<u>MEETING</u> HENDON AREA COMMITTEE
<u>DATE AND TIME</u> MONDAY 28TH JUNE, 2021 AT 7.00 PM
<u>VENUE</u> HENDON TOWN HALL, THE BURROUGHS, LONDON NW4 4BG

Re: The proposed alteration to The High Street/Milespit Hill, NW7

CadCorp images – High Street NW7 and part of Milesplit Hill

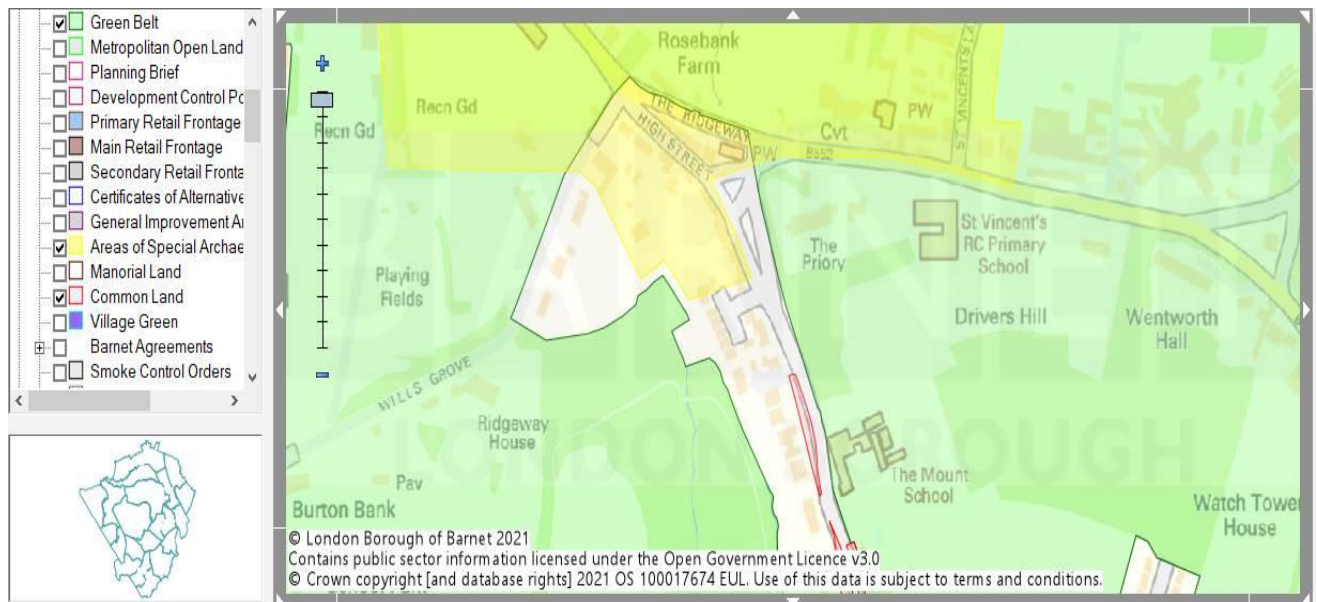
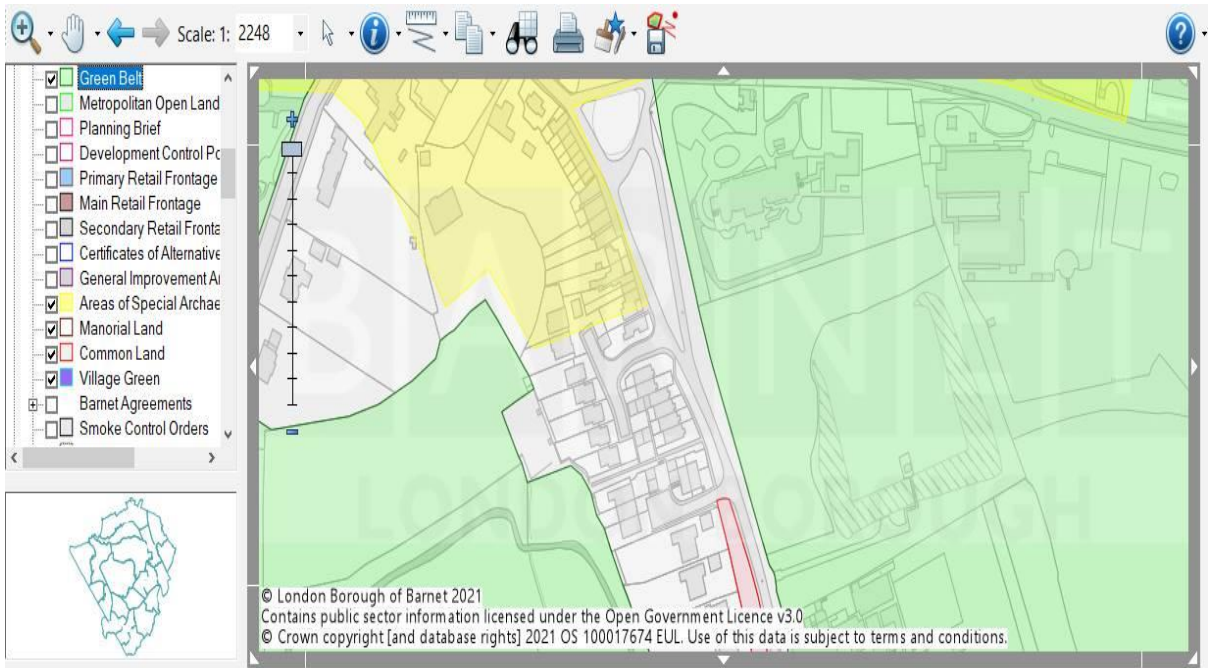
The Scheme hinges on the conversion of Registered Village Green /common land to highway as this is prohibited the scheme cannot be recommended to proceed. The precedent is a proposal at the other end of Milespit Hill and that didn't have the extra level of protection the conservation area affords yet was still refused due to encroachment of common land.

Dependent upon the removal of common land, Registered Village Green status means, it is not permitted. Increase of vehicles passing at close proximity to listed buildings

What consideration is given to listed buildings long term and the increased risk to young families walking in the road with one-way traffic behind them?

The Council's Planning Mapping system indicates that the proposed traffic signs, posts and minor verge conversion will not be carried out on any common land or the village green.

The area around the pond is not common land or Village Green. The pale yellow below is area of special archaeological importance.
